E8364B-03A

S E R V I C E N O T E

E8364B PNA Microwave Network Analyzers

Figure 1: A3 Front Panel Interface Board Assy without the Bracket

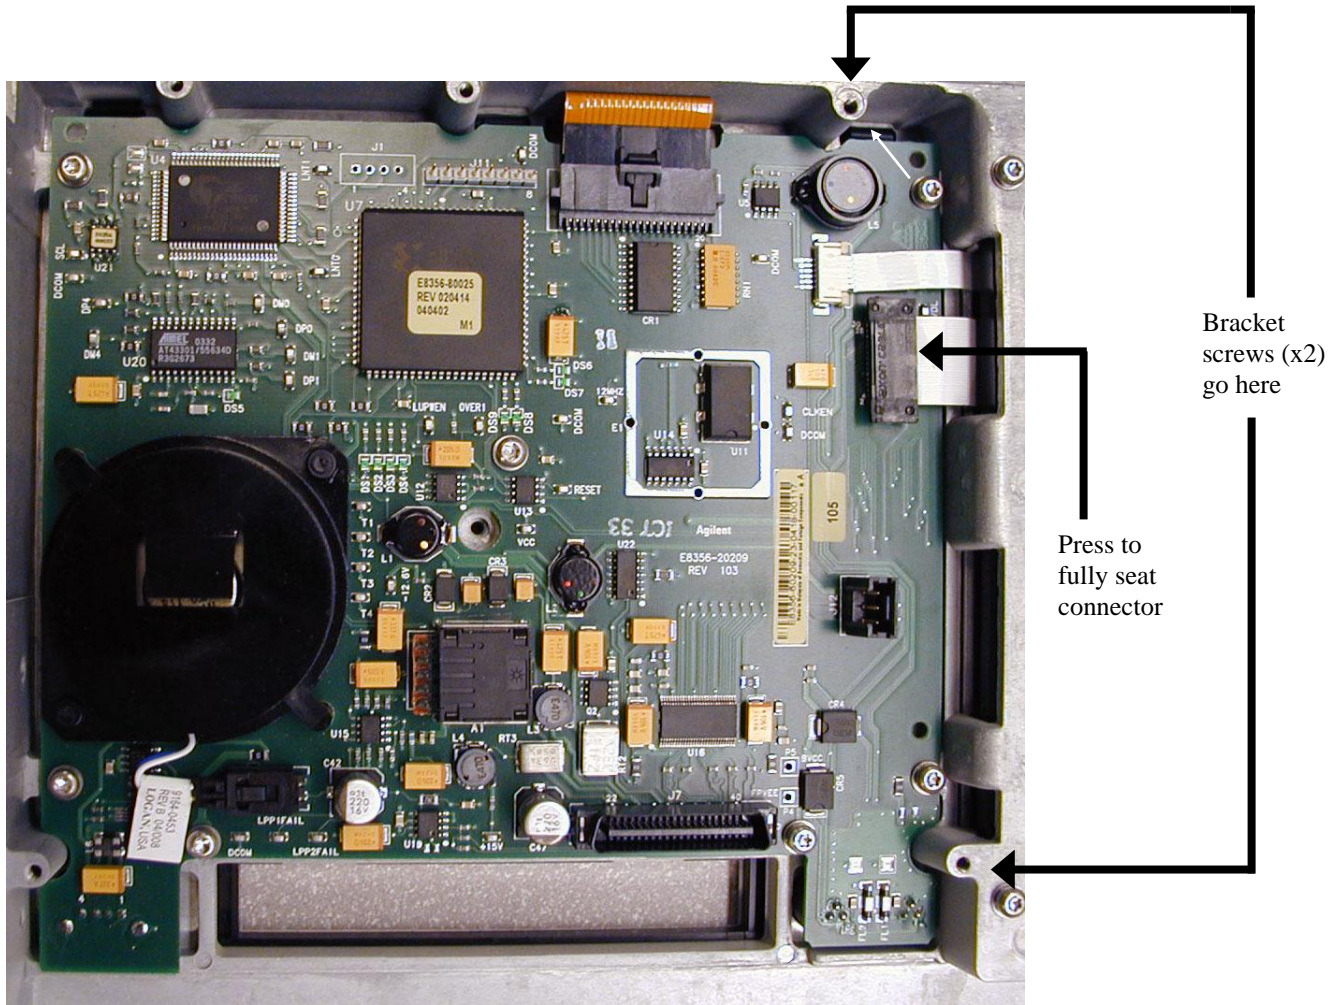
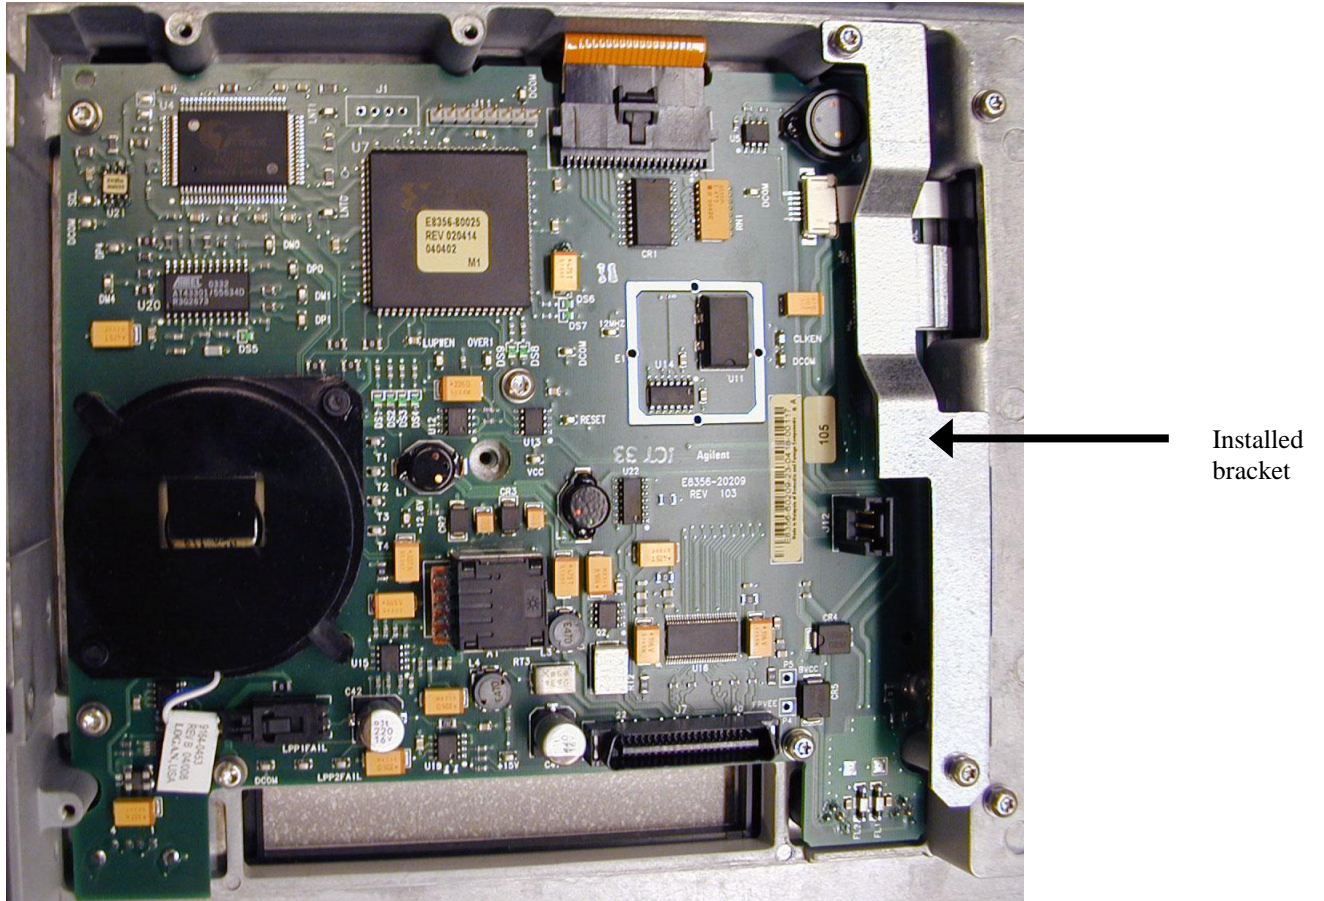
A connector of the ribbon cable (Agilent part number 8120-8409) that joins the front panel display to the front panel interface board can loosen, causing a display failure, unless a new bracket is installed. Because the failure rate has been very low, it is recommended that the bracket be installed only when there is an additional reason to remove the PNA front panel.

1. Refer to Figure 1 in this document:
 - Press down firmly on the ribbon cable's black connector.
 - Locate the two tapped holes for the bracket screws.
2. As shown in Figure 2 in this document, position the bracket so that its holes line-up with the two holes you located in the previous step.
3. Hand-start the two screws, and then torque both to 9 in-lbs.
4. Reinstall the PNA Front Panel by following the Service Guide instructions in the "Replacement Procedure." This is located on the same page as the "Removal Procedure" used previously in step 7.
